Addendum #3

Directorate of Facilities Engineering

21 January 2022

Bog Brook Kitchen Renovation, Gilead, Maine, Project Number 23TR19-603-D, BGS Project Number 3195, Bid Number 22-017.

3 RADON PIT DETAIL
SB101_P-101 SCALE: 1-1/2"=1'-0"

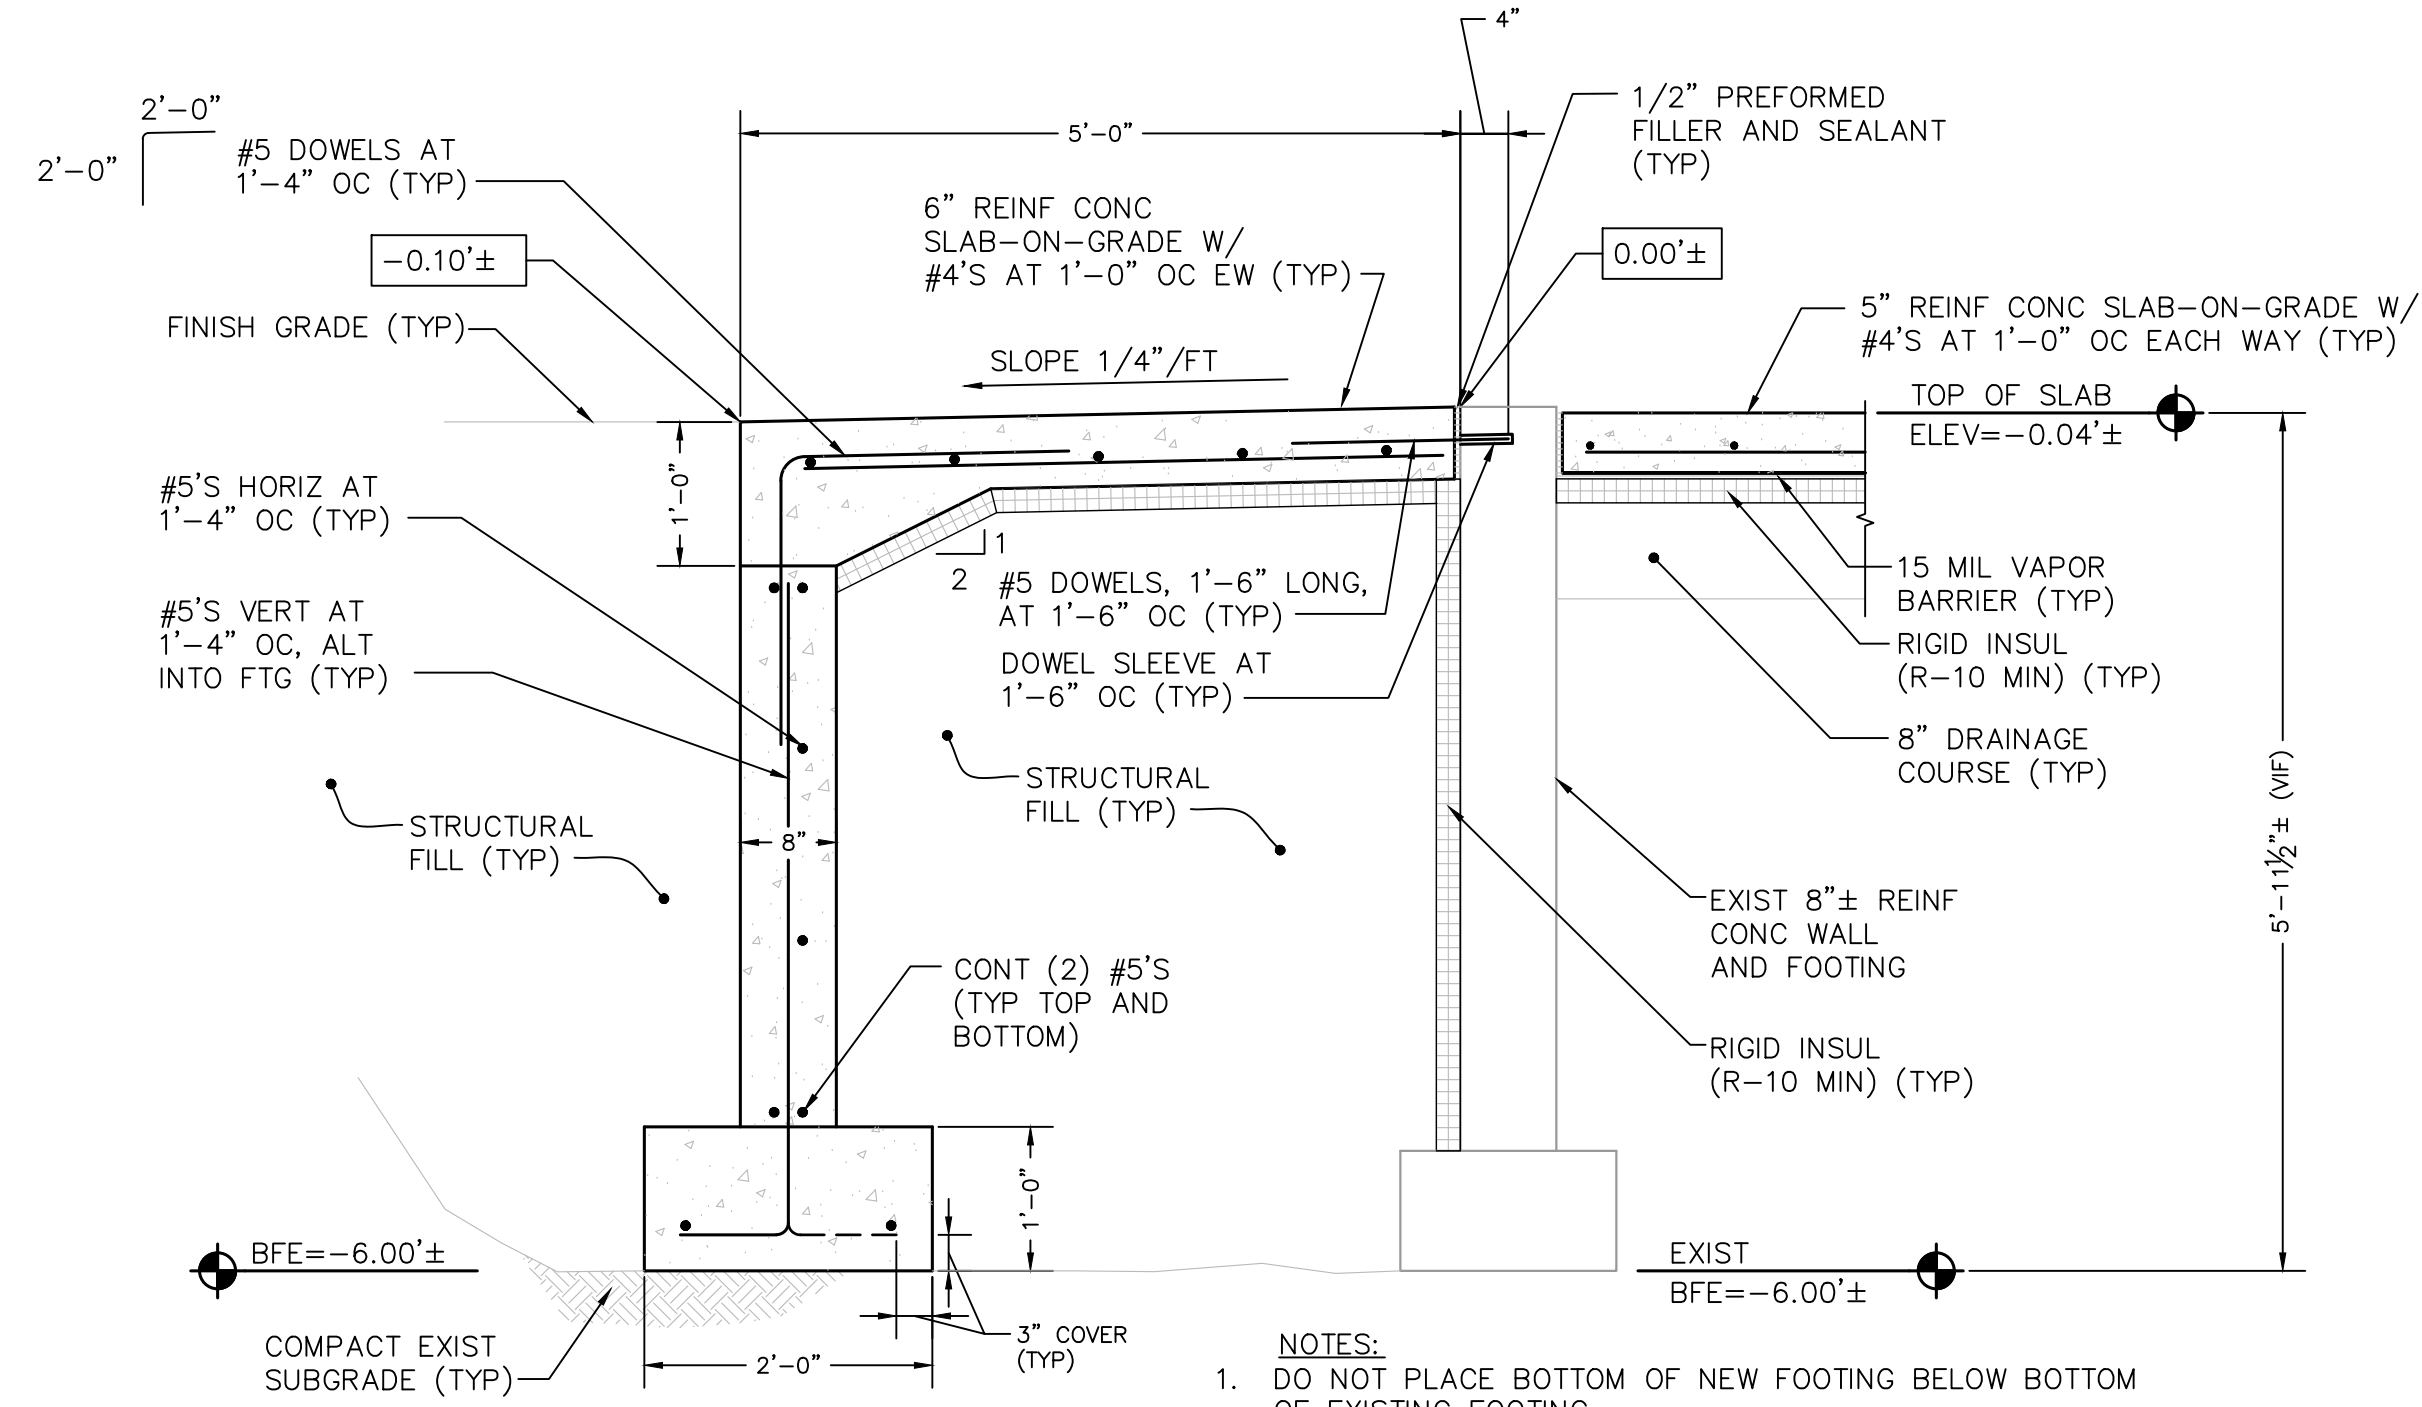
3. **Question:** Is MC cable allowed or only emt conduit?
Answer: Wiring must be in conduit.
4. **Question:** Will they be clarifying that note on 3/SB501? What is 8" expanded metal decking? The largest expanded metal that I can get is 1 1/2" NO 9. Needs to be a thin gauge so that it can wrap around the angles.

Answer: Note on detail 3/SB501 will be updated to clarify. Material is not decking, it is standard expanded metal.
5. **Question:** Is there an additional detail available for the "Non-Penetrating Roof Pads" on 3/AE501 for mounting the railing?
